Drainage Letter for

Arby's | Falcon, Colorado

Add PCD File No. PPR2041

Arby's | Falcon, CO
11775 Meridian Market VW
Falcon, CO 80831

SHEET NAME
STORM SEWER BASINS MAP

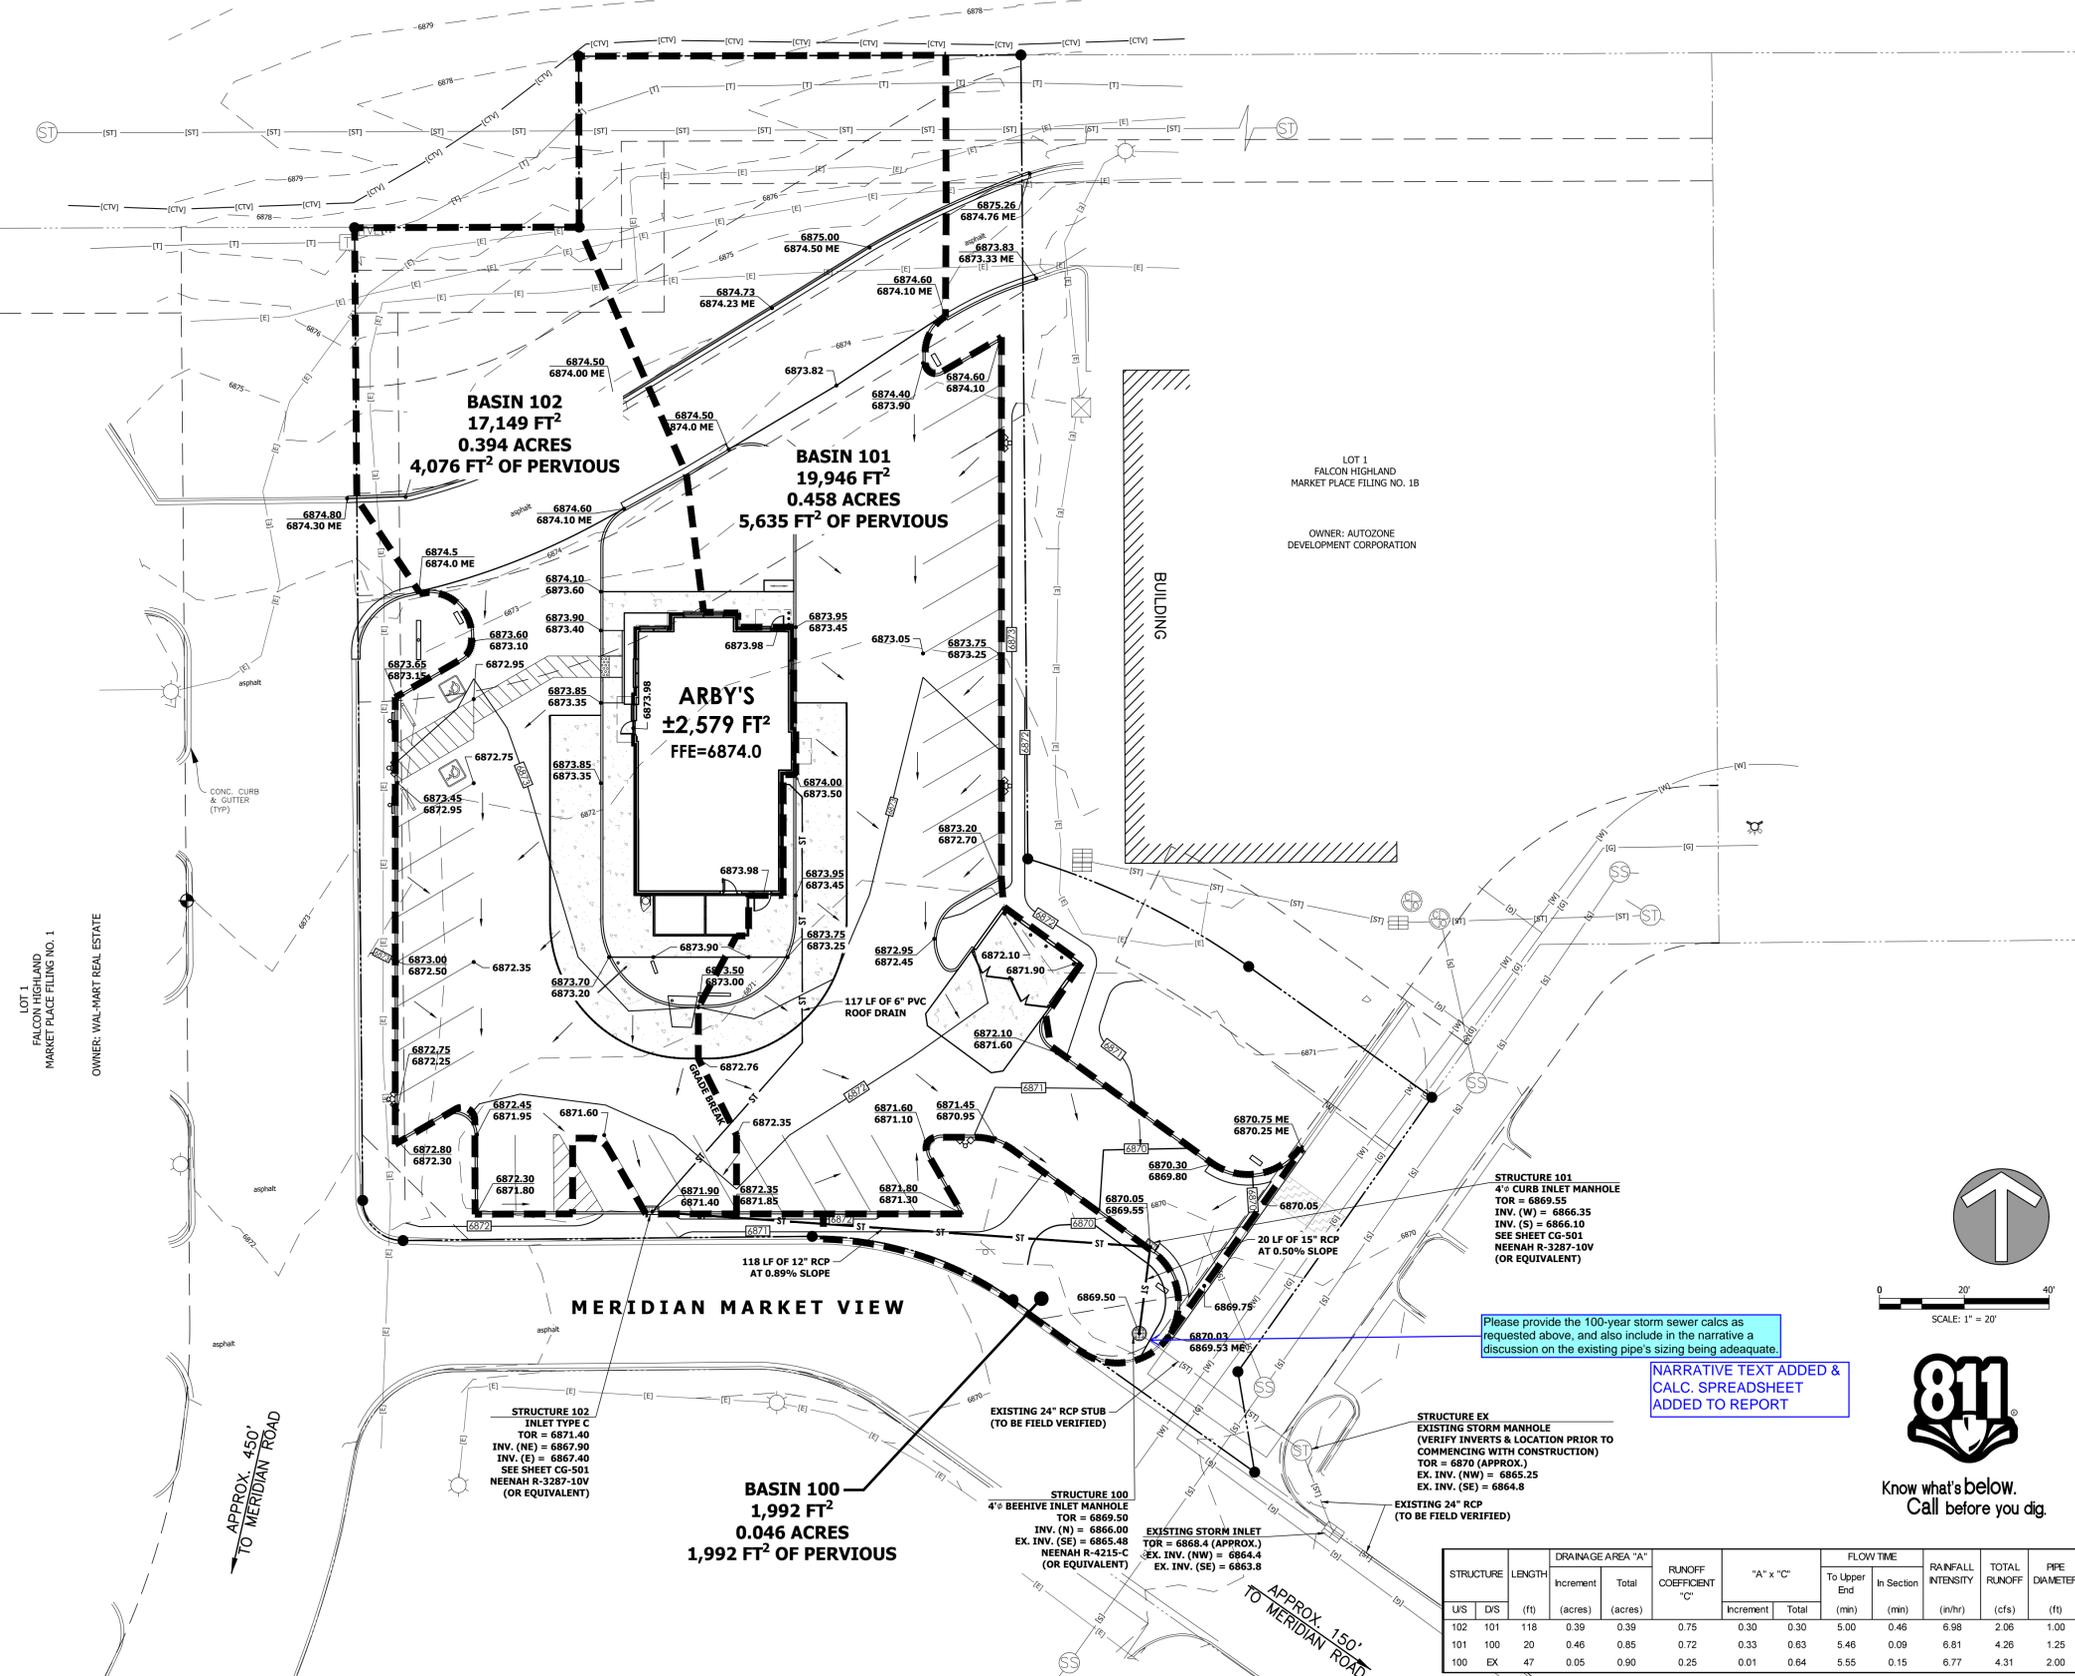
Please provide the 100-year storm sewer calcs as requested above, and also include in the narrative a discussion on the existing pipe's sizing being adequate.

NARRATIVE TEXT ADDED & CALC. SPREADSHEET ADDED TO REPORT
